Project	Steamboat Base Village Redevelopment	Date	07/23/2021
Project Location	Steamboat, Colorado	Architect's Project Number	03.7835.000
Owner/Client	Alterra Mountain Company / East West Partners	File	6BL This is page 1 of 2
To	Saunders Construction Inc.	Attention	Bryan Sculthorpe
Address	86 Inverness Place North		
City	Englewood	State	CO Zip Code 80112
Delivered via:	<input type="checkbox"/> Messenger <input type="checkbox"/> Hand carried <input type="checkbox"/> Facsimile <input type="checkbox"/> Express <input type="checkbox"/> Pick-up <input type="checkbox"/> E-mail Address <input type="checkbox"/> Mail <input type="checkbox"/> UPS <input checked="" type="checkbox"/> Website Address BIM360

Bulletin Number - BP3 Promenade - 06

Description of Changes

This bulletin addresses the following:
Landscape planters, site walls, associated grading
Telecom sheet updates for on mountain coordination

1A-L7-02

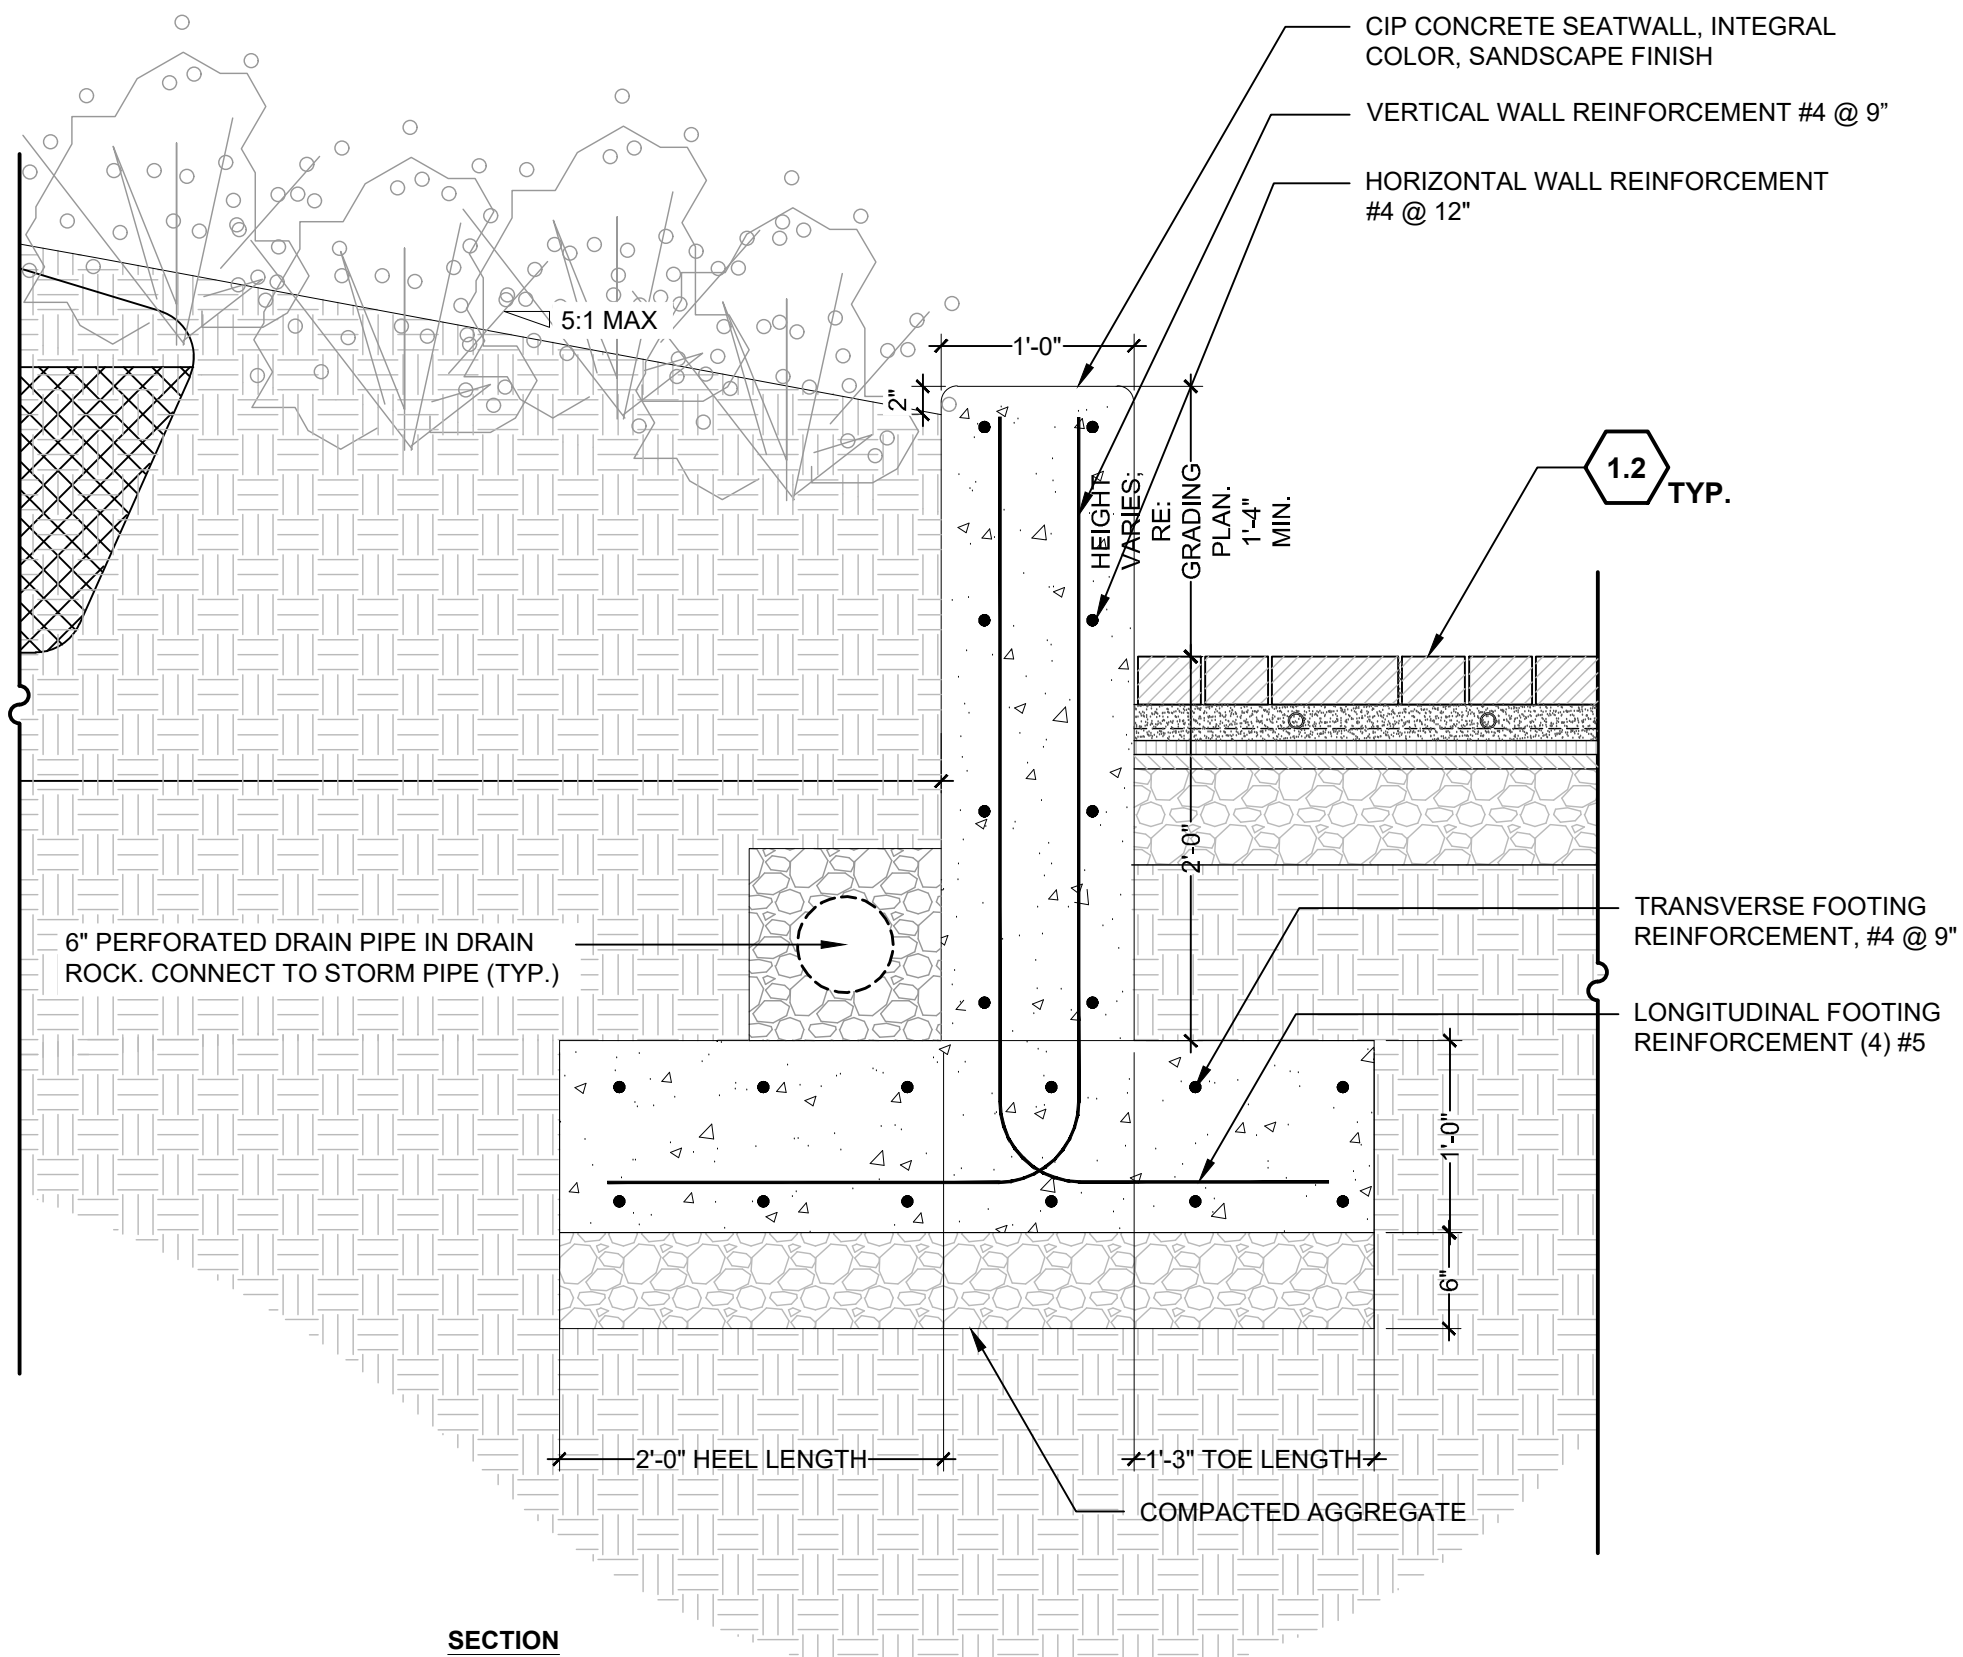
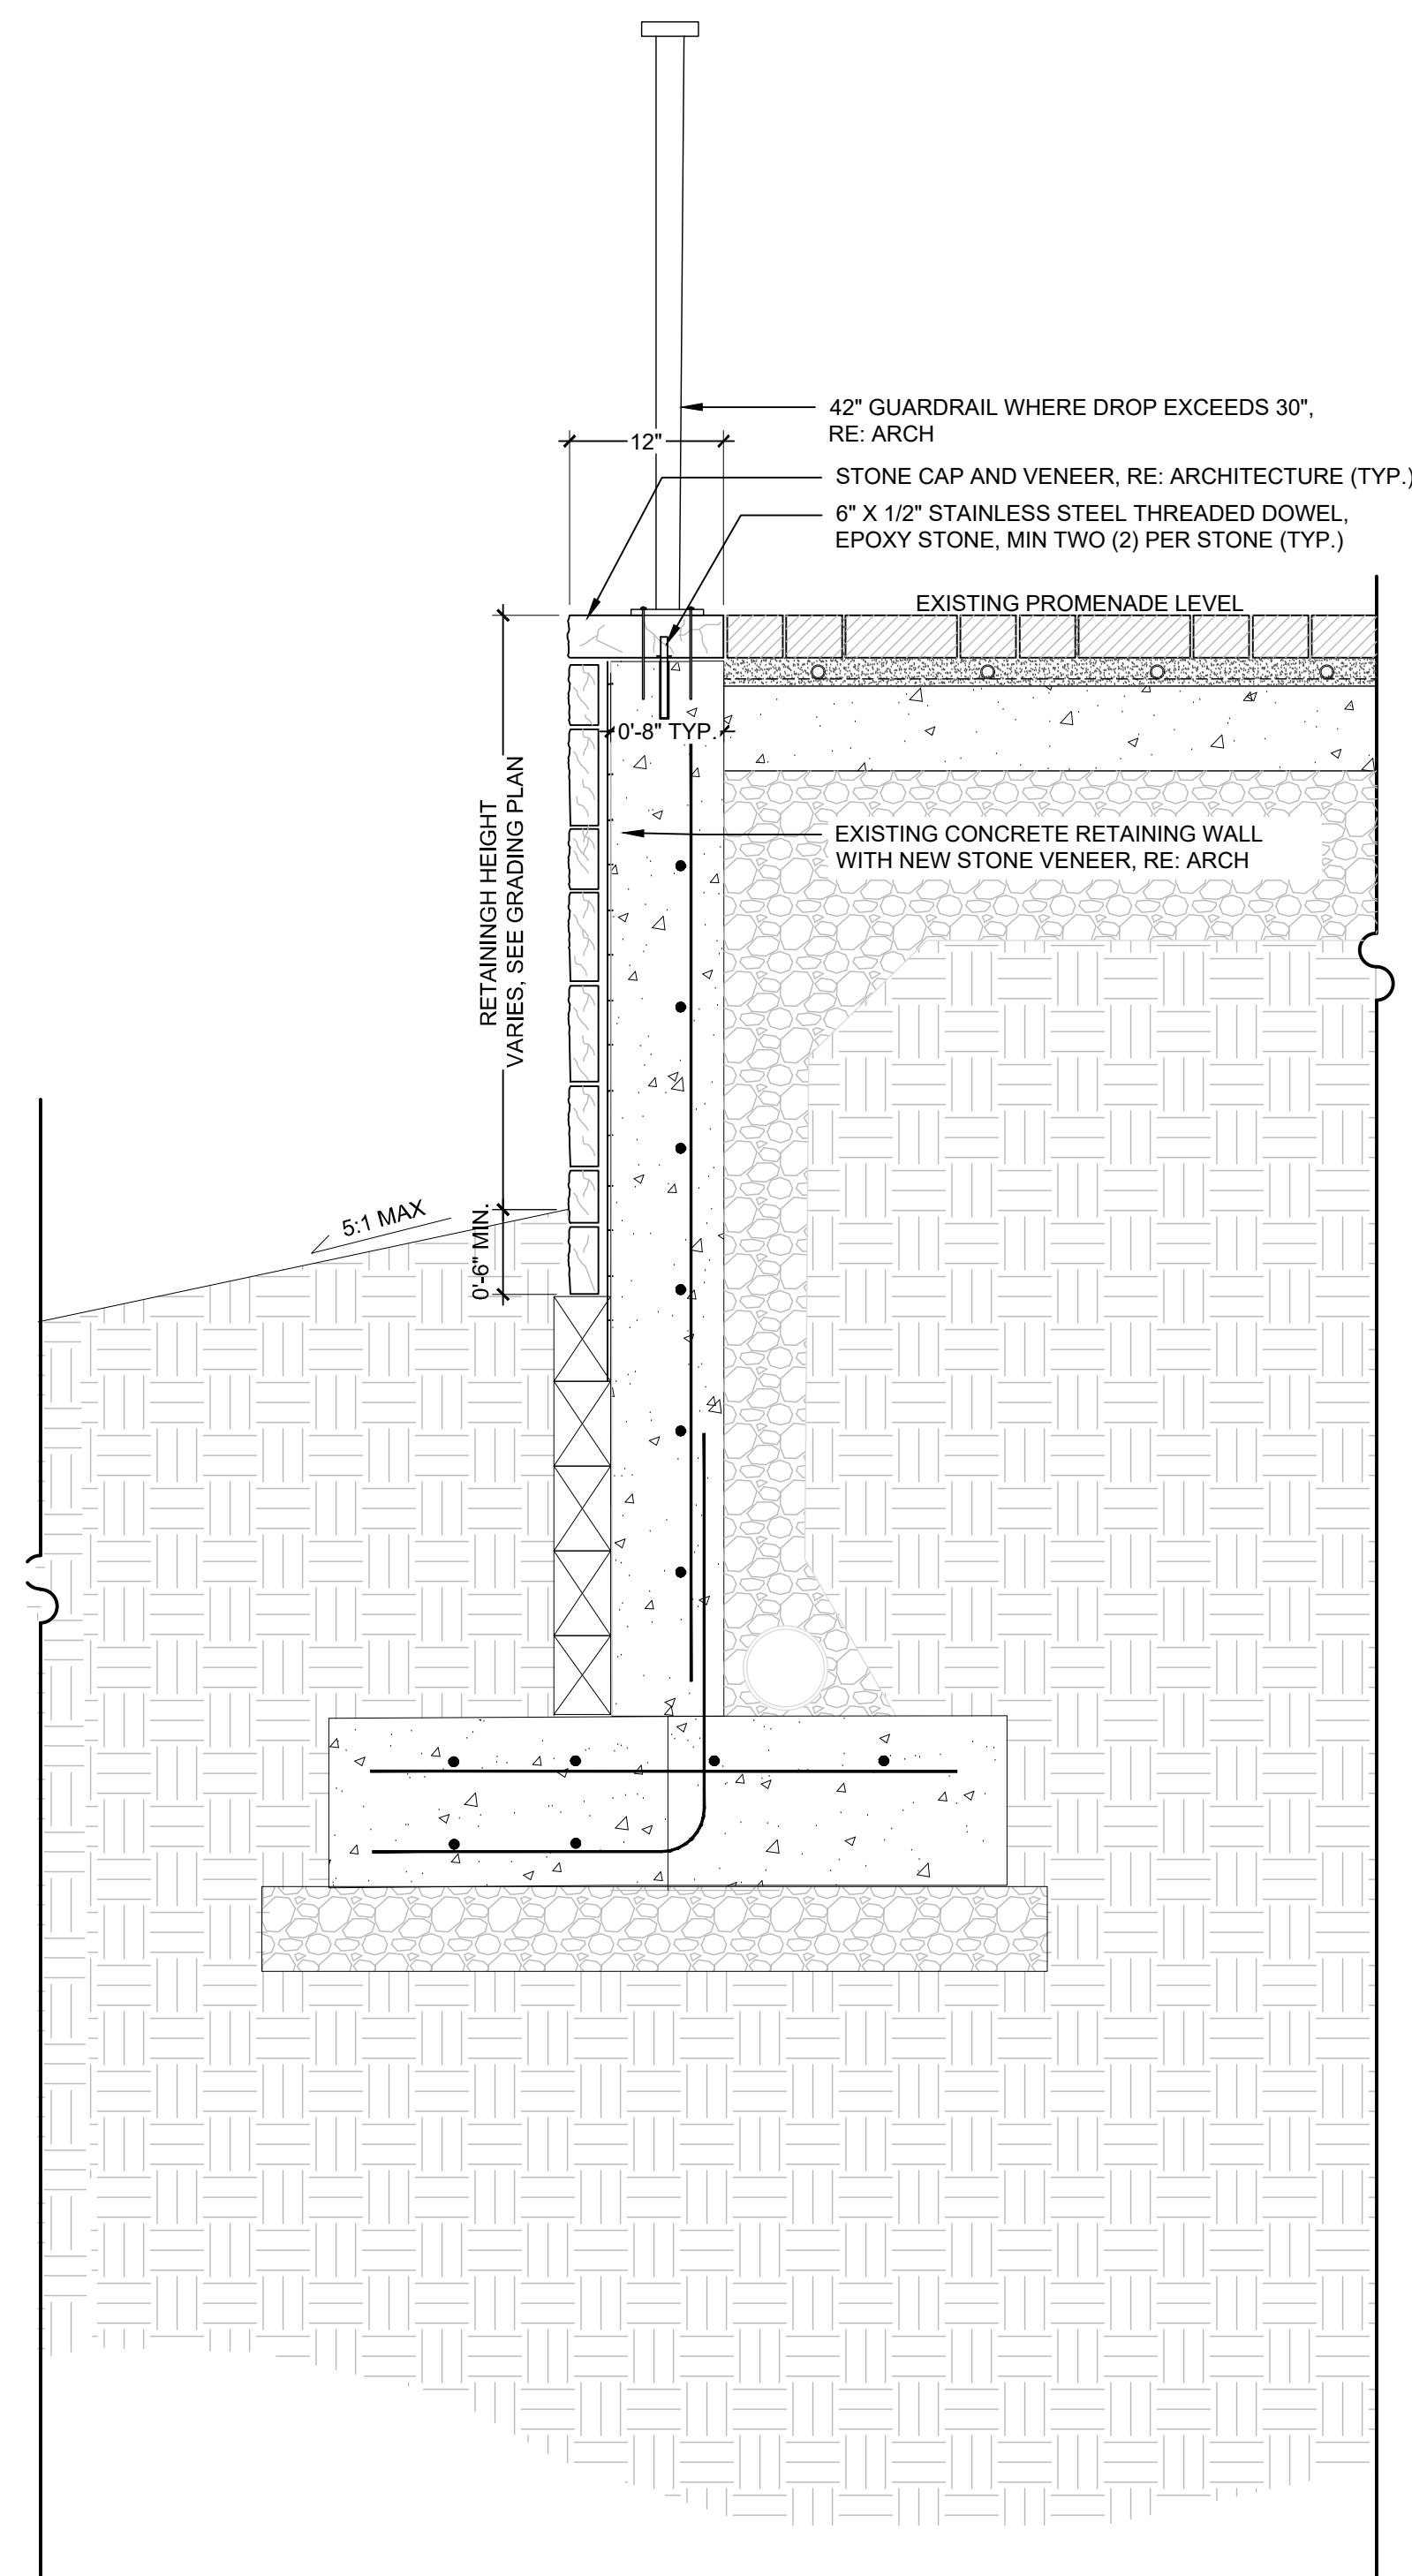
1A-L7-02 Site Details	Section 2 revised to include wall type 5.
1A-L7-03 Site Details	Sections 2 and 3 revised/added to show wall details type 3 and 4.
1A-L7-04 Site Details	Section/Elevation 1 title change to wall type 2.
1A-L7-08 Composite Sections	Elevation 2 added and elevation 3 revised to show relationship of southern promenade walls and transformer.
1A-L7-11 Site Details	New sheet showing wall types 5 and 6.
1A-L8-01 Planting Plan	Eastern tree removed from northeastern planter, shrubs and groundcovers reduced to accommodate new planter size.
1A-L8-02 Planting Plan	Trees, shrubs and added to fill larger planter at lower promenade level.
Irrigation Sheets:	
1A-IR-01 Irrigation Plan	Adjusted irrigation to match new planter geometries.
